ATHENS FULL SERVICE MAINTENANCE FACILITY

OHIO DEPARTMENT OF TRANSPORTATION

TMCC AS-BUILTS
[FIELD SET]

THOMAS & MARKER CONSTRUCTION

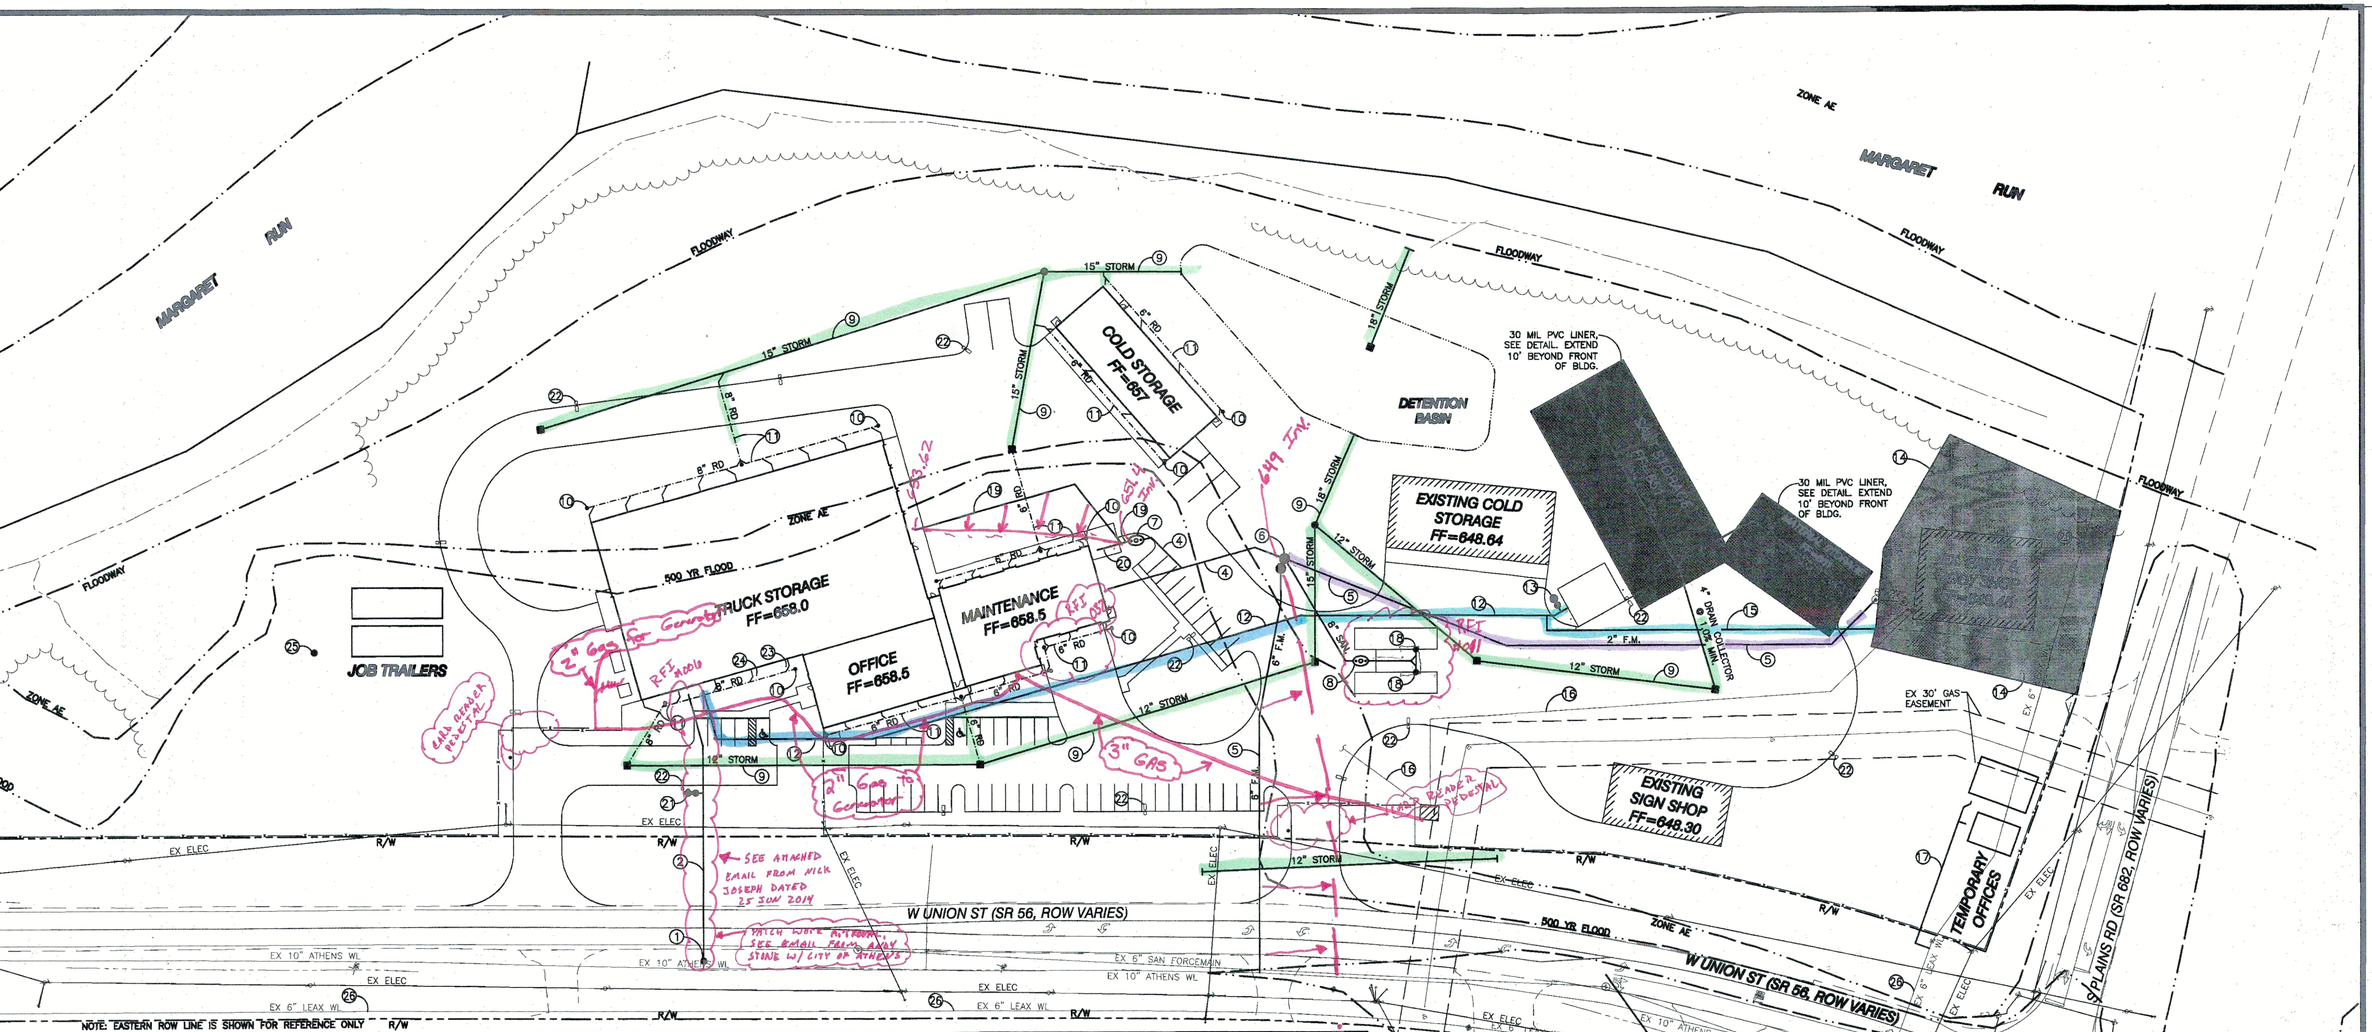
Site drawing C301 calls out and shows a new single 6" Fire Line from existing City of Athens Water line across the street of West Union Street to inside the Truck Storage building. No new domestic water line is shown nor is a new tap shown on the civil drawings.

On plumbing drawing PT201, it shows and calls out a 6" incoming fire line and a 4" incoming domestic water line. Note 2 says see civil drawings for continuation.

1. Reference attached updated sheet C301. The sheet shows the location of the existing 6" LEAX water line (keynote 26).
2. Reference the spec section 22 13 23 for use.

AF201

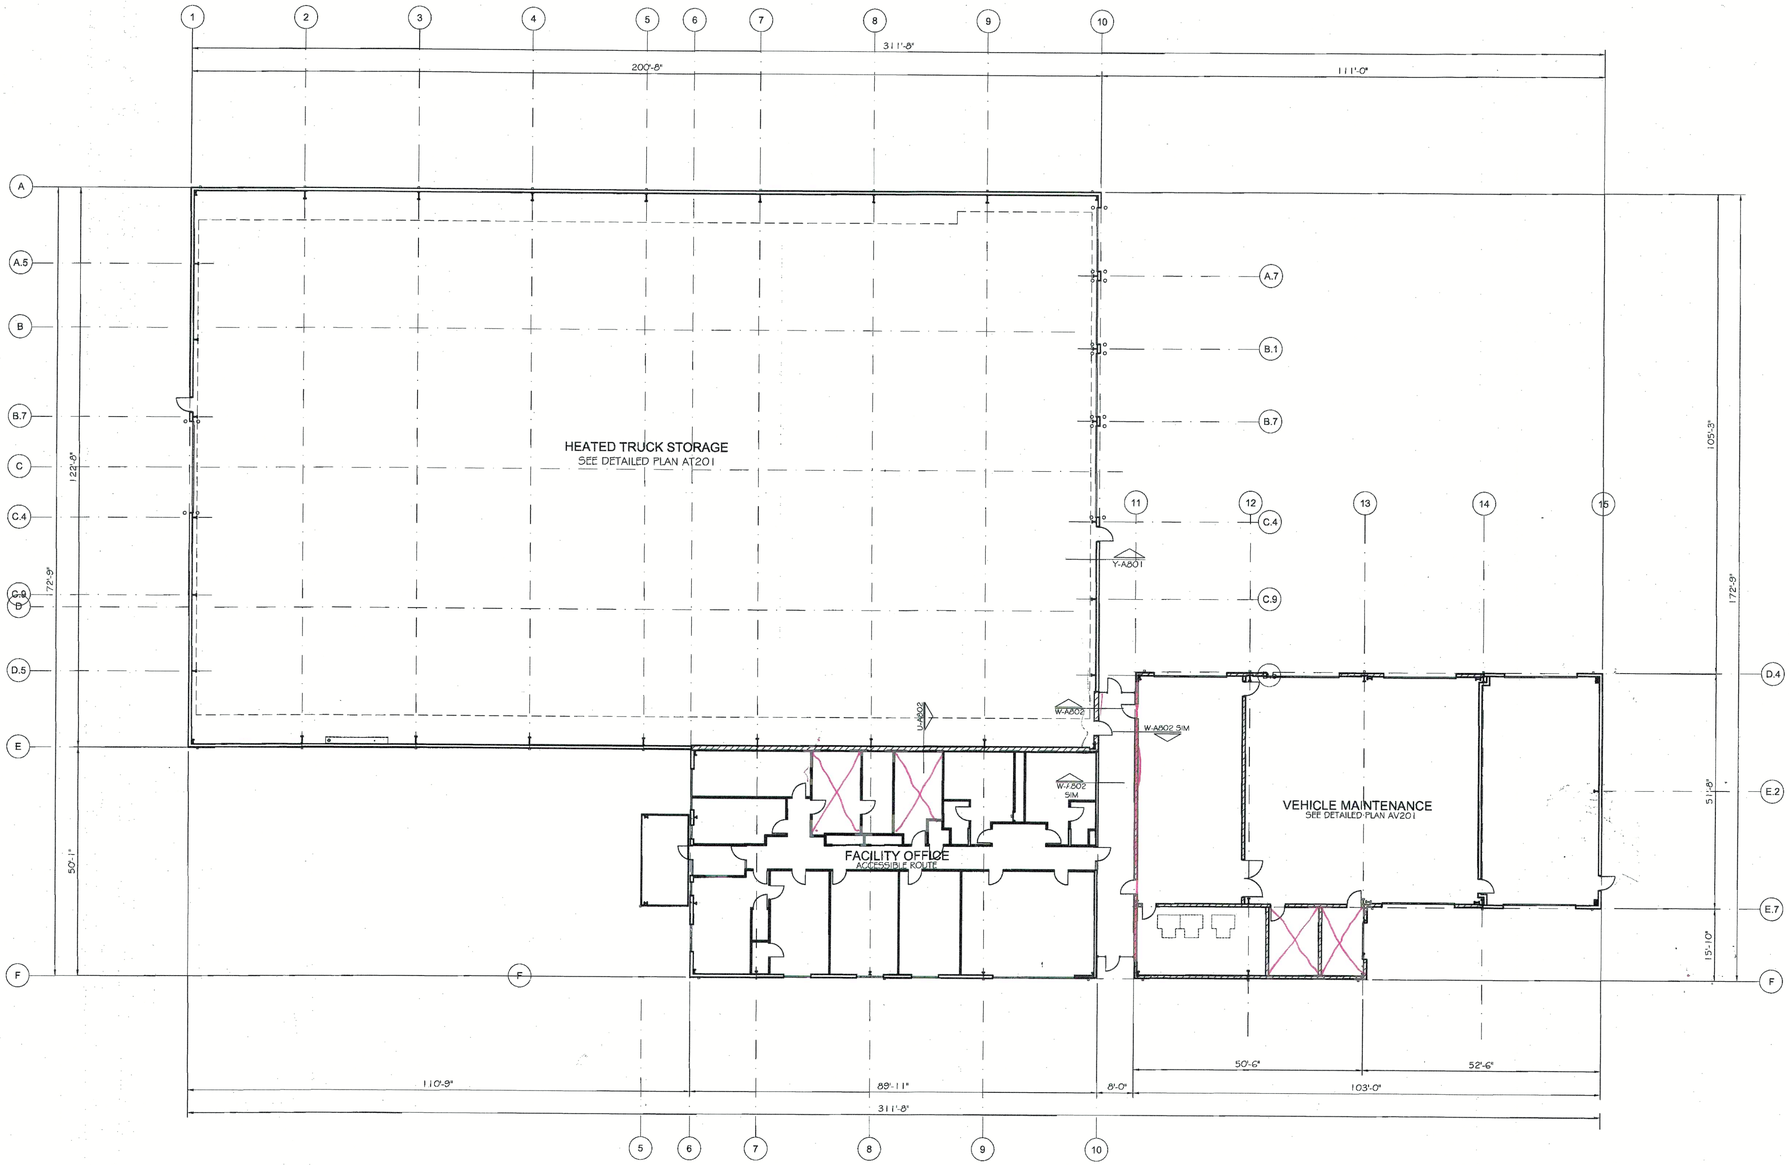
Drawing C301 of the Balance of Project shows an H shaped concrete pad but the detailed drawing on AF201 calls for a 26'-6" x 15'-0" solid square pad. We need clarification for which design to go off of.

Please confirm if we need to go off the AF201 detail, or if the H shape on sheet C301 is the desired design, if that is the case then please indicate the details and dimensions for total pad.

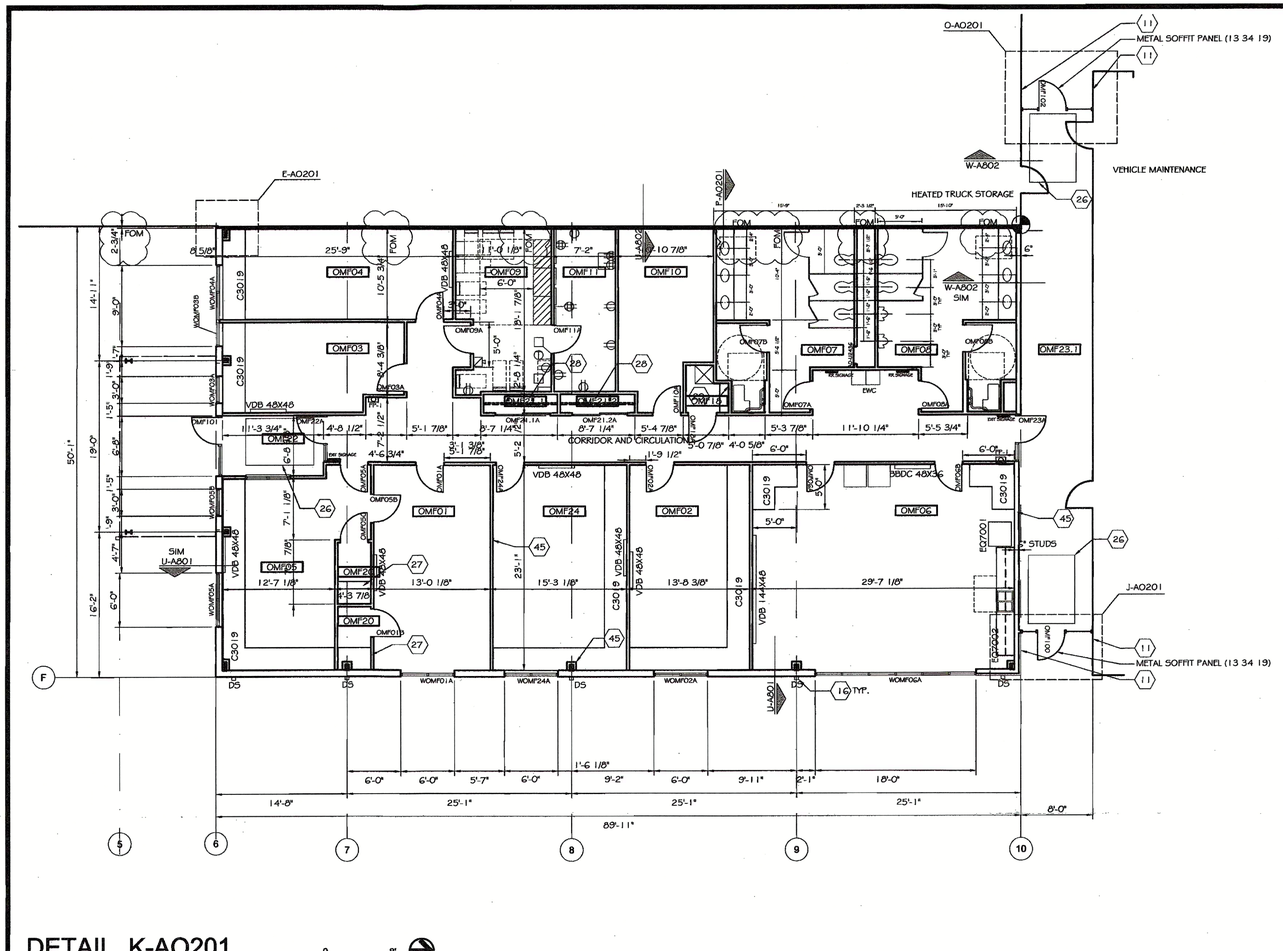
DESCRIPTION:
Vehicle Maintenance Clear Wall Area

In Vehicle Maintenance, group building services to maximize unobstructed free wall area.
ODOT wants useable areas of unobstructed wall to mount tools and equipment.

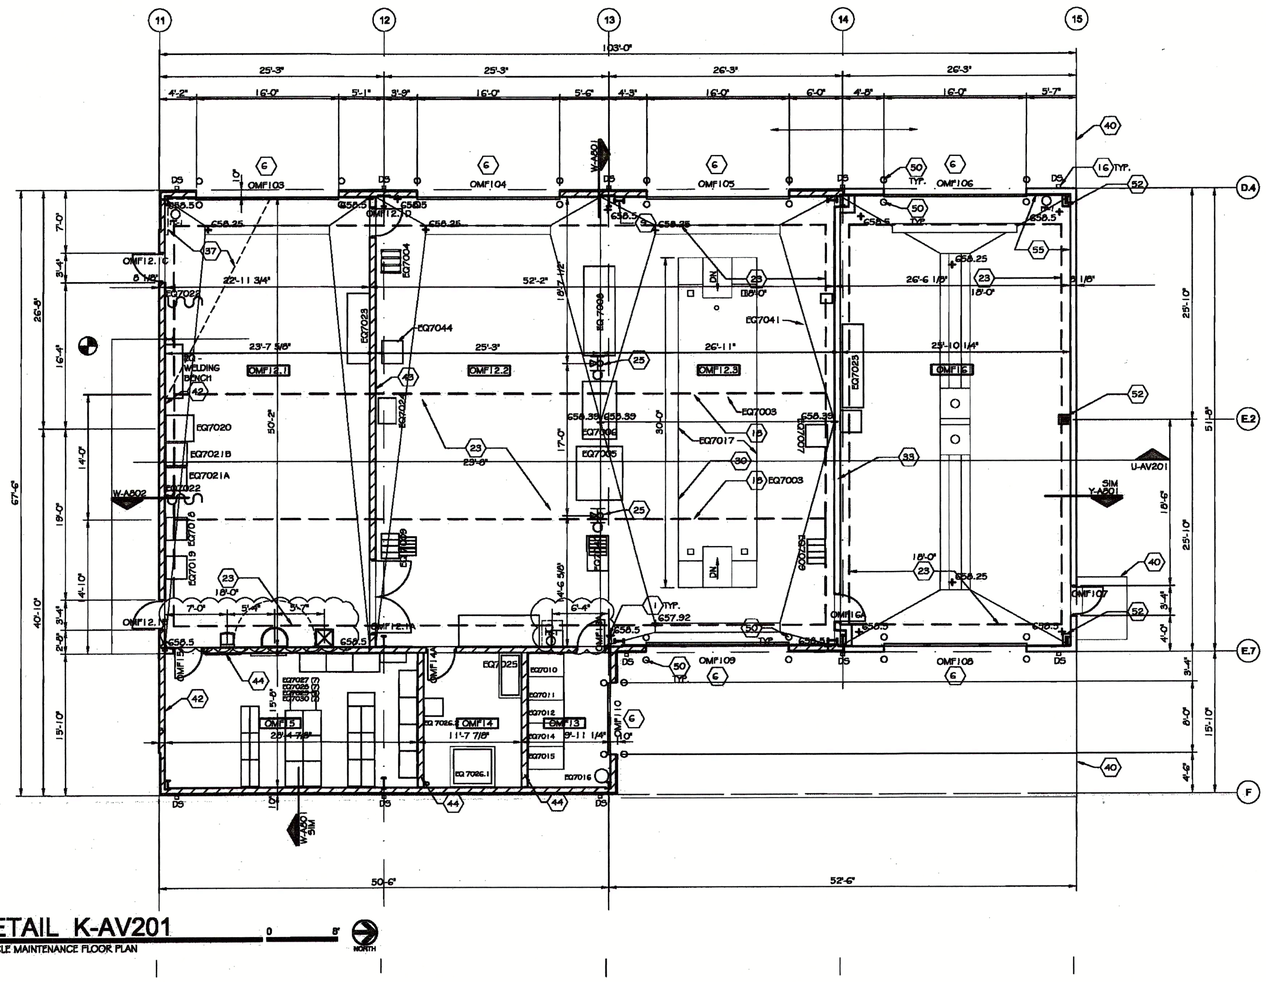
On drawing AT201, it shows a hand washing station, mop sink and emergency shower. It shows a wall between these plumbing fixtures. What type of wall is this wall? There are no dimensions, please provide dimensions for location of wall? Keep in mind the UG plumbing is already installed.

8/25/2014 - IT IS UNDERSTOOD THIS RFI DOES NOT REFER TO FLOOR ELEVATIONS AT VEHICLE LIFT, BUT RATHER TO TRUCK STORAGE HAND WASH / UTILITY CENTER AT LINES INDICATED IN RFI.
SEE DETAIL E-AT201, DETAIL J-AT201, DETAIL O-AT201, AND DETAIL T-AT201 ON AT201 REVISED 8/25/2014.

IN LIEU OF E5/EW-1 BRADLEY 519345HFB, PROVIDE BRADLEY 519314 (BOTH LOCATIONS T501 AND OMF12.2)
